ADDENDUM NO. 1

PAWTUCKET RIVERFRONT BIKE PATH AND LANDSCAPE IMPROVEMENTS – BID #15-037

Addendum #1 – August 19, 2015

SK-001

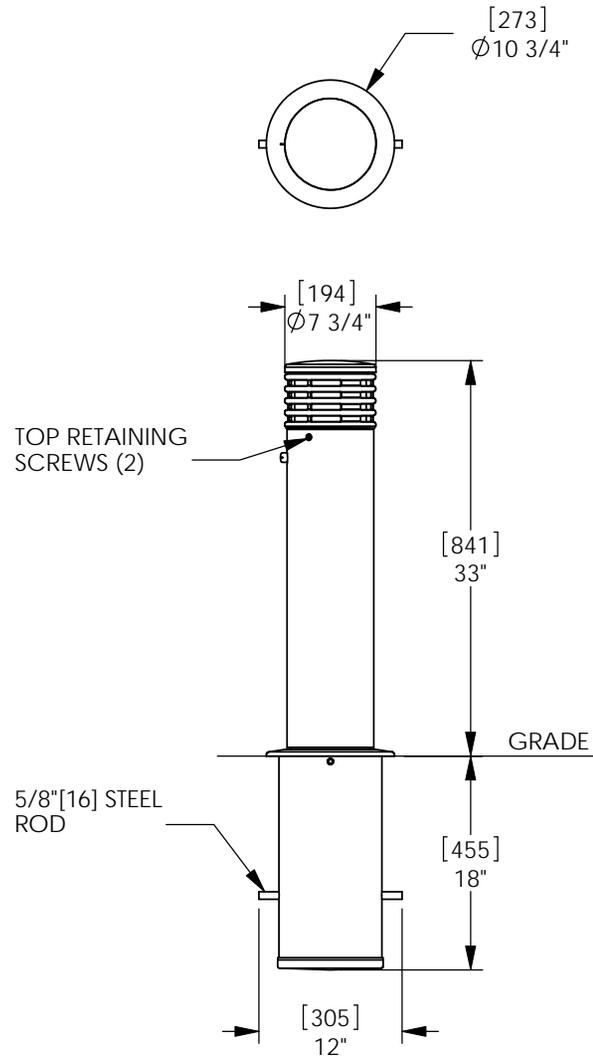
1. Electrical connection revised plan shown on SK-001, see attached. There are 2 available conduits available in the box located in the retaining wall that lead back to the electric panel in the basement of the fire station. There are five-20 amp circuits available for use.
2. Information on brick paver - Paver Type: Holland by UNILOCK; Size-Standard, 8" x 4" x 2.36". Color to be determined by owner.
3. Light Bollard: Annapolis by Landscape forms. See attached detail. Color: Black
4. Sign-in sheet for 2/10/14 pre-bid meeting (i.e. list of qualified bidders), see attached.

CONTRACTOR TO USE EXISTING 1" CONDUIT TO CONNECT TO MAIN PANEL WITHIN BASEMENT AREA
